Subject: DRAFT Revised Response to U.S. EPR Design Certification Application RAI
No. 218, FSARCh. 3, Question 03.04.01-8
Sent Date: 10/26/2012 5:41:24 PM
Received Date: 10/26/2012 5:41:47 PM
From: WILLIFORD Dennis (AREVA)

**Request for Additional Information No. 218 (2613), Revision 0
Question 03.04.01-8
05/15/2009**

**U. S. EPR Standard Design Certification
AREVA NP Inc.
Docket No. 52-020**

**SRP Section: 03.04.01 - Internal Flood Protection for Onsite Equipment Failures
Application Section: 3.4.1**

Sheet 7 of 10

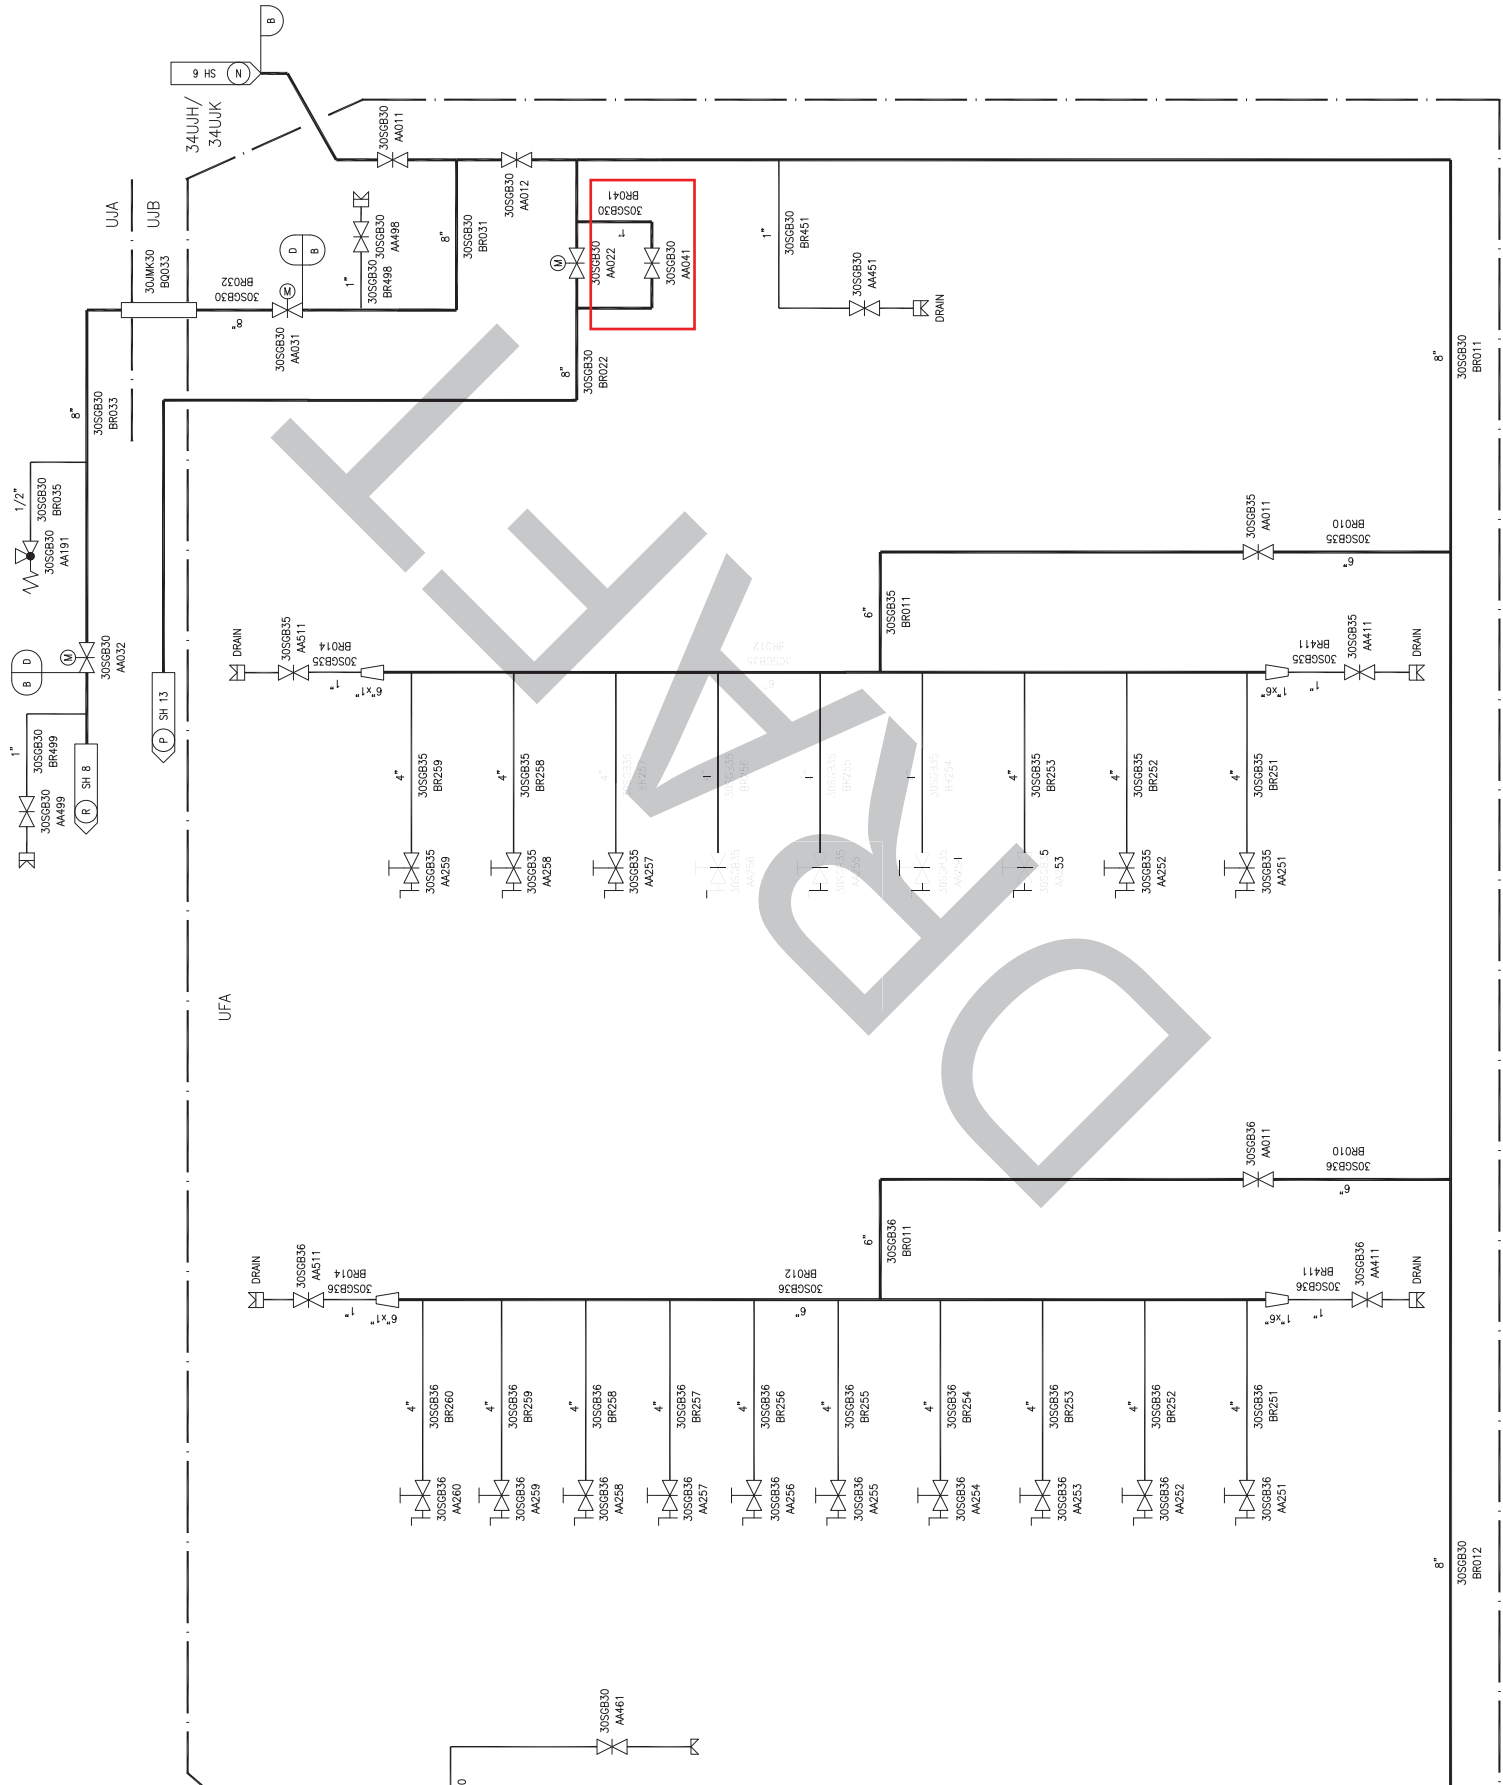
- U.S. EPR FSAR Tier 2, Figure 9.5.1-1 (Sheets 4 and 7) was revised to add a normally open bypass line around the FWDS annulus isolation valves. (Note these changes were reflected in Revision 2 of the U.S. EPR FSAR).
